# Access Compliance Report Public Rights-of-Way (Curb Ramps)

Main Street: HEWES\_AVE Cross Street: VALE\_AVE Location: NE

ADA ID: RPAT211015131531 Ramp Type: Type 3 - Combination 1 Initial Pass/Fail: Fail Overall Compliance: No Severity Score: 30

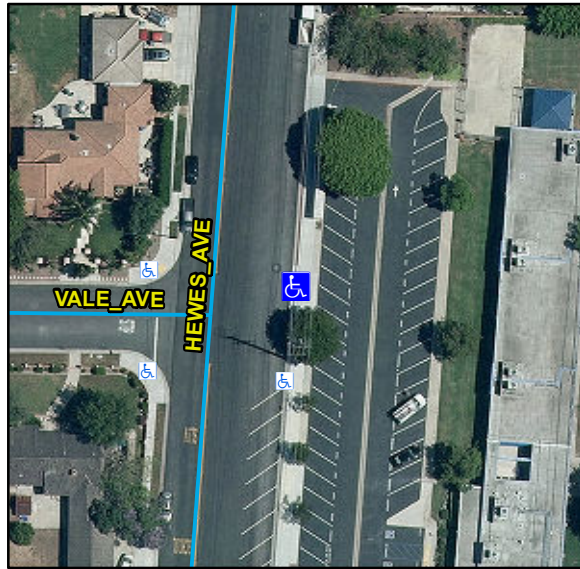
**R304.3.2, R304.5.3, STD 1115**

| Compliance | Description                           | Data | Compliance | Description                   | Data |
|------------|---------------------------------------|------|------------|-------------------------------|------|
| No         | Ramp Run Slope LT (%)                 | 8.8  | Yes        | Ramp Run Slope RT (%)         | 1.6  |
| No         | Ramp Cross Slope LT (%)               | 5.7  | Yes        | Ramp Cross Slope RT (%)       | 1.4  |

**Remove & Replace Entire Ramp.**
